From: KOWALSKI David J (AREVA NP INC)
Sent: Monday, April 26, 2010 1:26 PM
To: BRYAN Martin (EXT)
Cc: BALLARD Robert W (AREVA NP INC); CONNELL Kevin J (AREVA NP INC); HUDDLESTON Stephen C (AREVA NP INC); GARDNER George Darrell (AREVA NP INC)
Subject: RAI 345 Supp 1 DRAFT RESPONSES
Importance: High

Please transmit to Getachew Tesfaye the attached partial set of DRAFT responses to RAI 345 questions. These responses will be discussed at tomorrow's (4/27/10) FSAR Chapter 9 Weekly Telecon/GoToMeeting with the NRC.

Question 09.02.01-37:

Figure 9.2.1-1—Essential Service Water System Piping & Instrumentation Diagram
Sheet 1 of 4

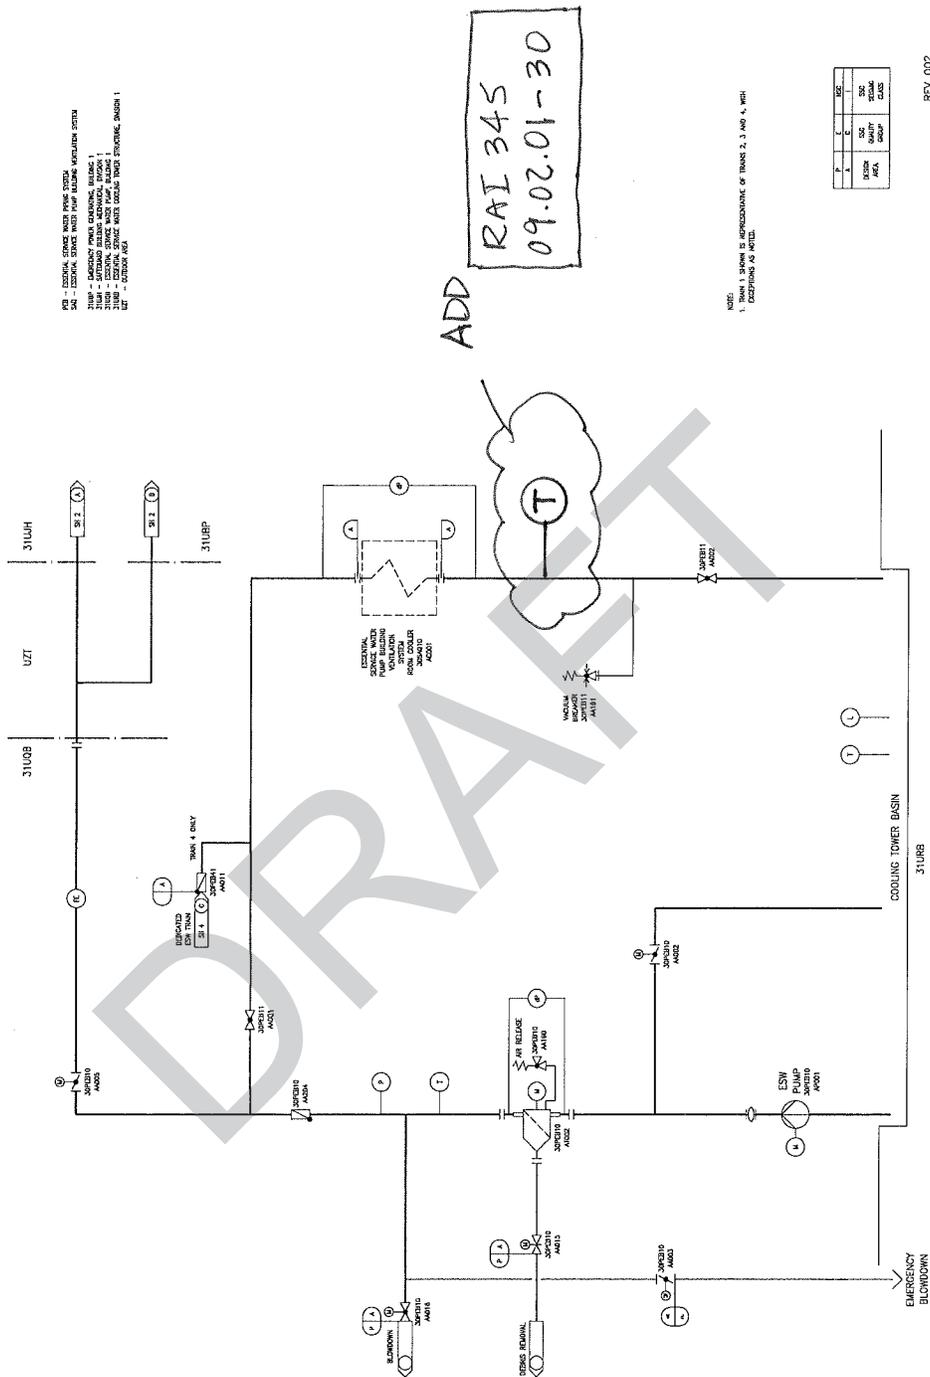
Part (f)- The P&ID does not show a flow indicator for the ESWS pump room coolers and additional discussion is needed to explain how the ESWS flow rate through the pump room coolers will be periodically verified and confirmed to be adequate.

The staff reviewed the applicant's response to part (f) of RAI-response 9.2.1-04 above relative to means of periodic confirmation of the adequacy of ESW pump room cooler flow. In this response, the applicant stated that temporary flow instrumentation will be installed for the performance of periodic cooler surveillance testing and testing after repairs. The staff found this response to be unacceptable since plant operators will not have valuable information related to ESWS possible degraded flow rates or degraded heat exchanger performance. This instrumentation should be described in the FSAR.

Indication of the ESW pump building room temperature is provided in the MCR as listed in Tier 1, Table 2.6.13-2. ESW temperature measurement is provided at the discharge of the ESWS pump and will be added downstream of the pump building ventilation system room cooler. Differential pressure across the cooler and temperature indications are available in the control room; therefore, plant operators will have information related to possible ESW degraded flow rates or degraded heat exchanger performance. The differential pressure is also available locally.

Indication of temperature measurement downstream of the pump building ventilation system room cooler will be added to U.S. EPR FSAR Tier 2, Figure 9.2.1-1. New instrumentation will be added to U.S. EPR FSAR Tier 2 Tables 3.10-1 and 3.11-1.

ADD
 RAI 345
 09.02.01-30
